Subject: Request for Proposal 2 - Changes to Backfill at Interior Retaining Walls

Project Name: Camden Rockport Middle School

Potential Change Order #007

Request for Proposal No. 002

SCALE: NTS
DATE: 08/15/18
REV: **SK-C3**
**CLARIFICATION
SKETCH**

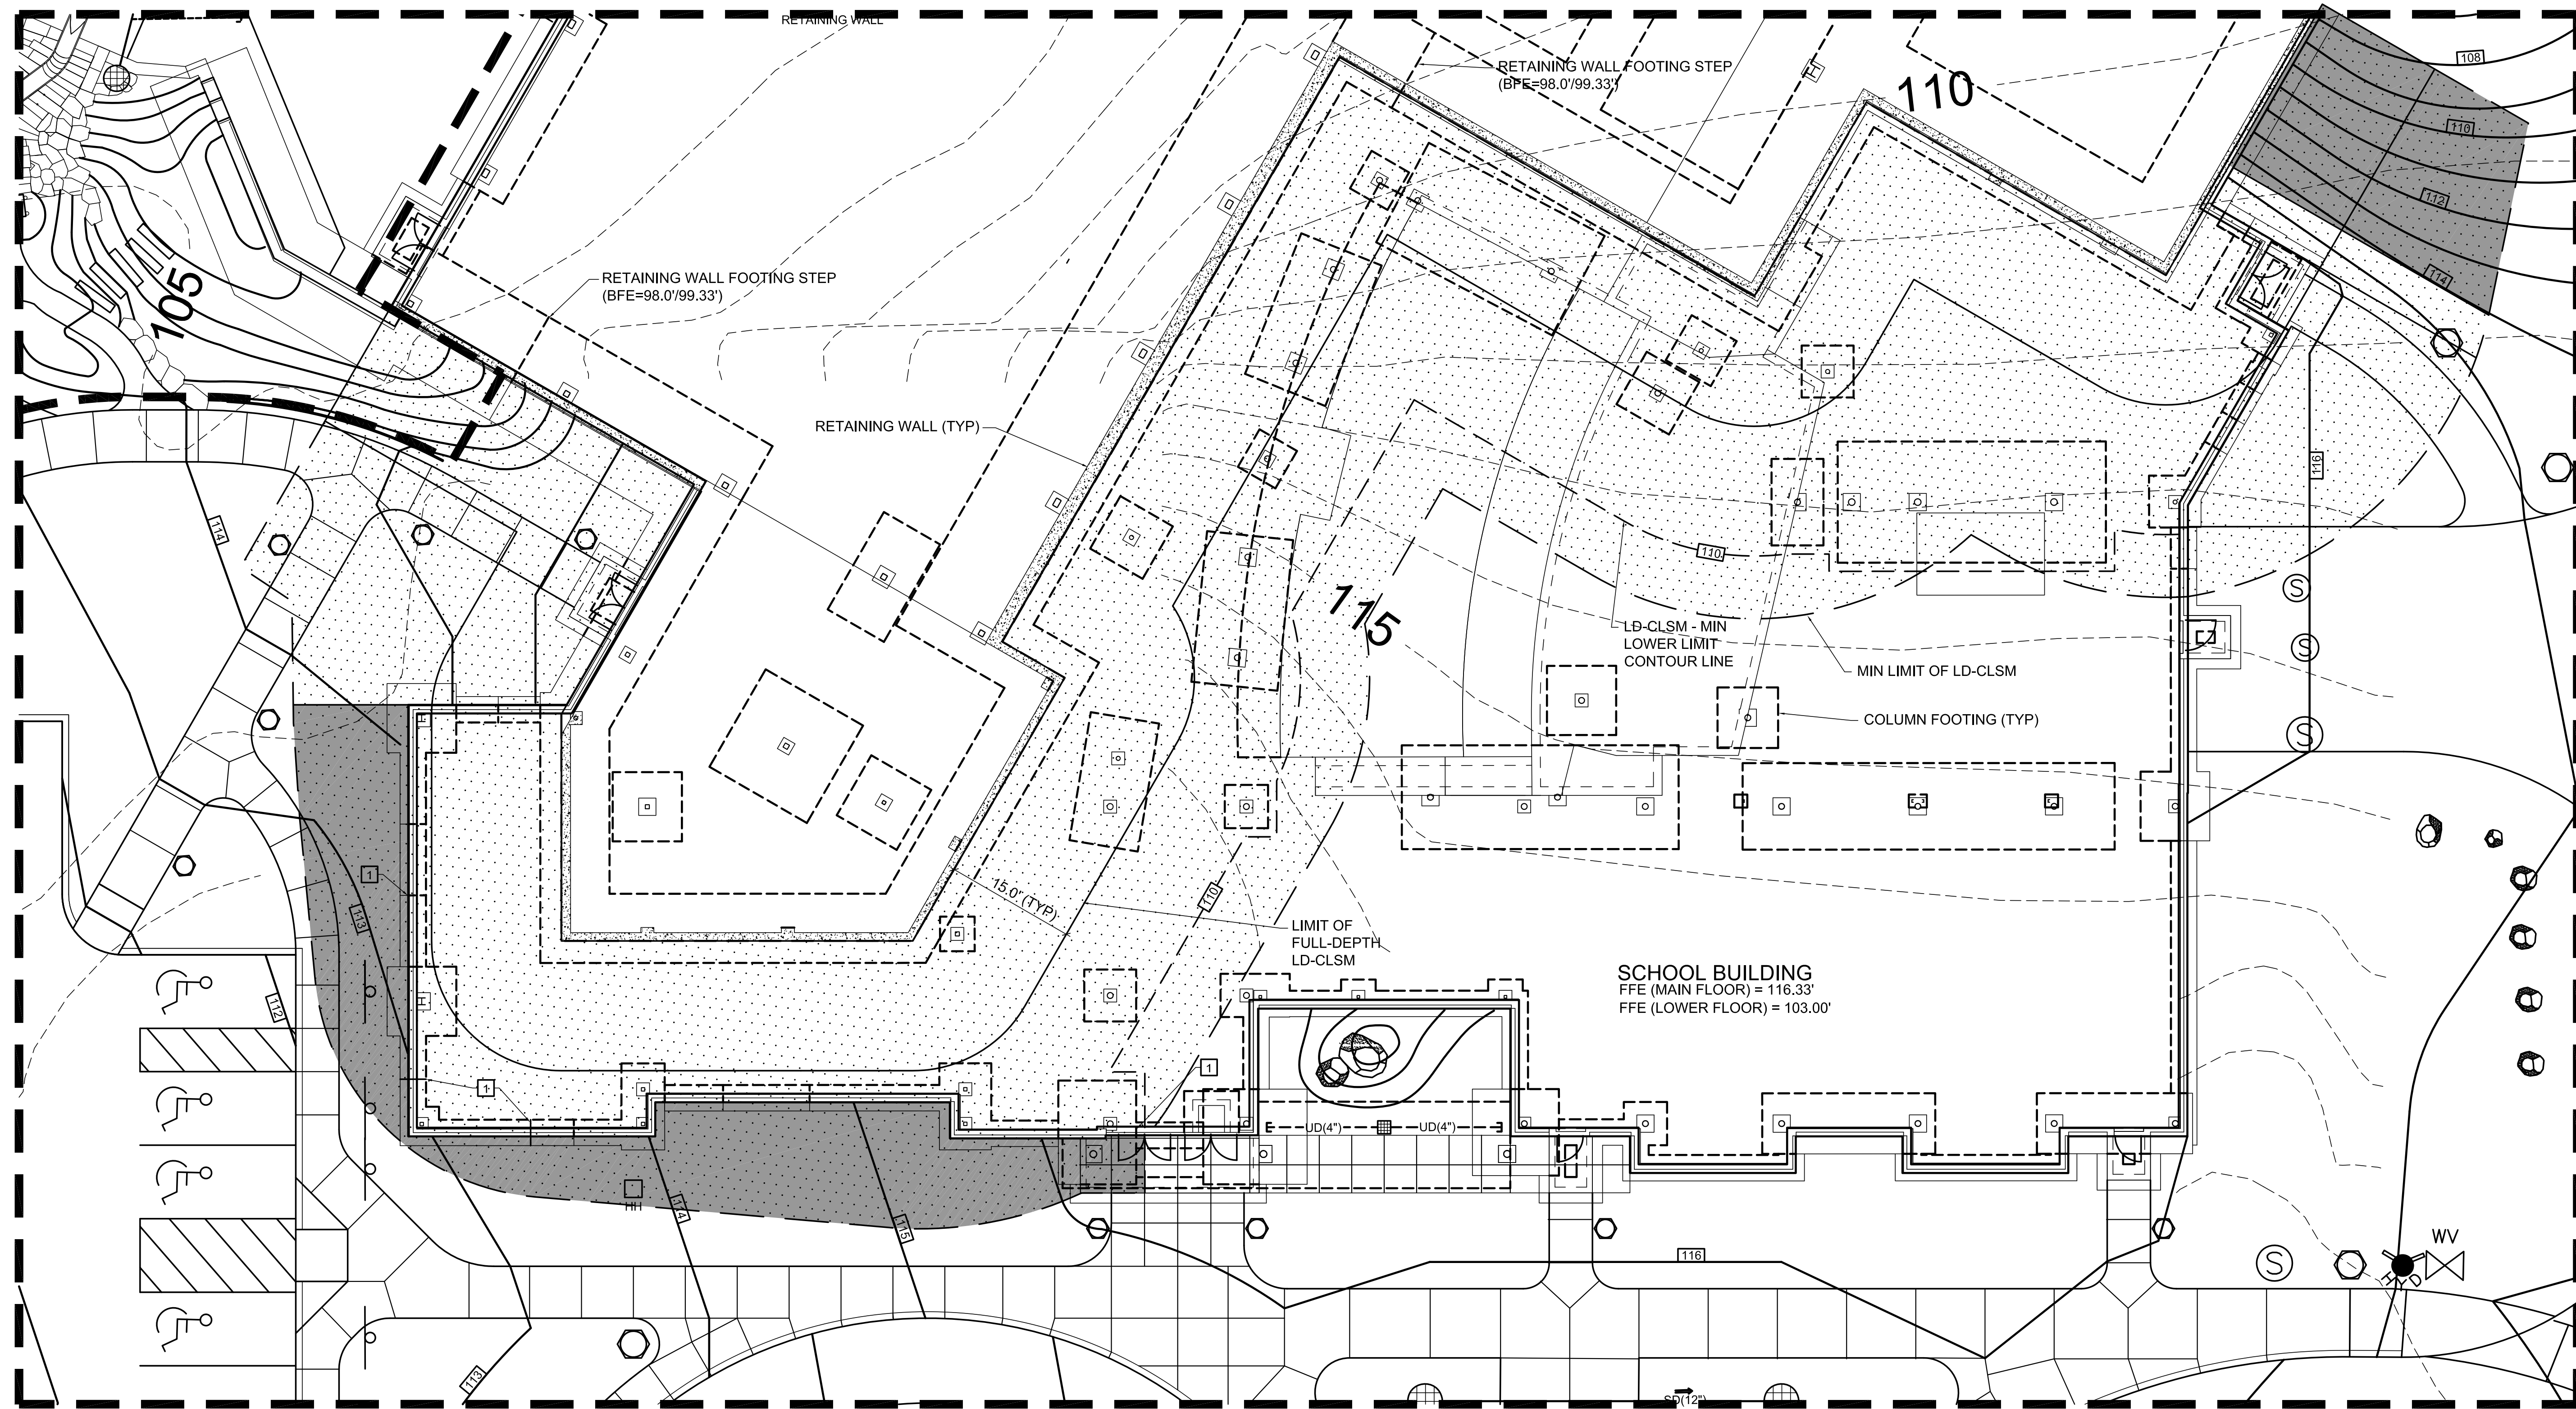
1. Delete crushed stone backfill and geo-grid reinforcing around reinforced concrete retaining and foundation walls.
2. Provide low density controlled low-strength material (LD-CLSM) at reinforced concrete retaining and foundation walls. Refer to SK-C2, SK-C3, SK-C4 and SK-C5 for extent of LC-CLSM material

1. THE LD-CLSM SECTION AT THE EXTERIOR OF THE EXTERIOR FOUNDATION WALLS INDICATED ON SHEET SK-C4, MAY BE BACKFILLED WITH CRUSHED STONE ABOVE THE BOTTOM OF FOOTING ELEVATION.

OAK POINT ASSOCIATES DRAWING NO. **SB102**
SHEET NO. 65 OF 369

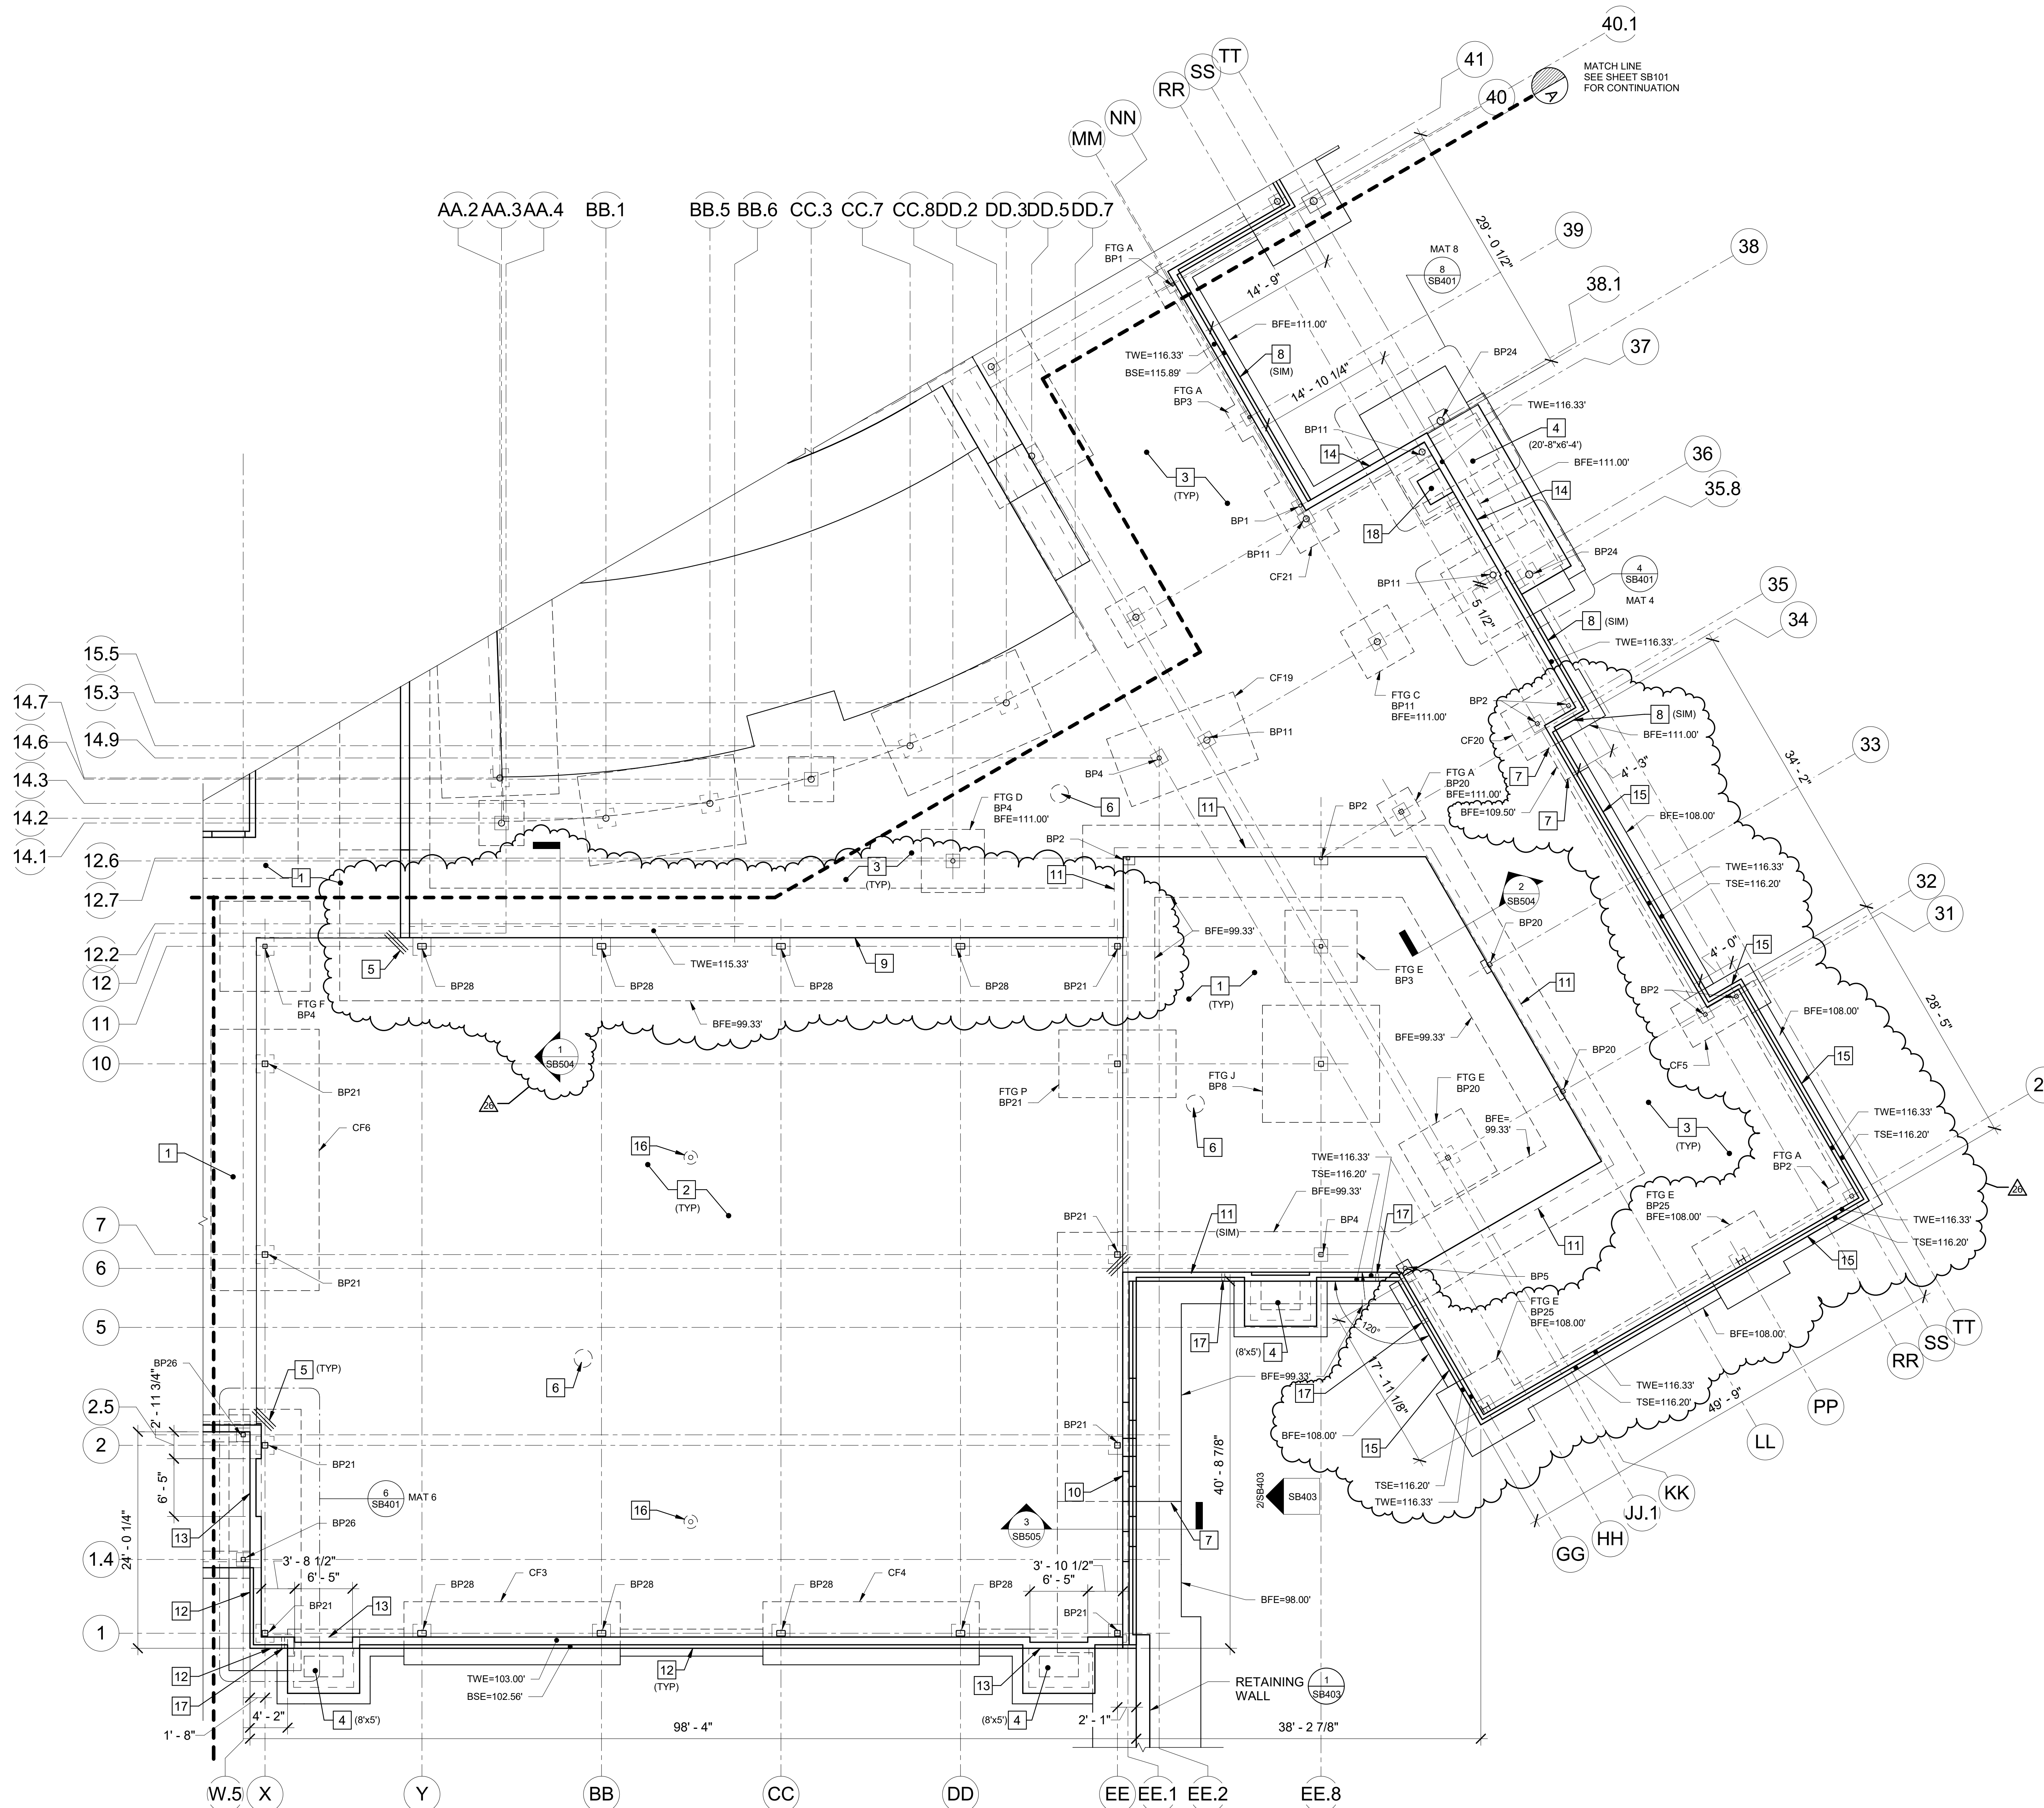
3. Revise reinforced concrete retaining wall indicated in detail 1/SB504.
4. Refer to attached drawings SB102 (**Revised 08-22-18**), SB503, SB503, SB504 and SB505 for modifications to foundation plans and details.
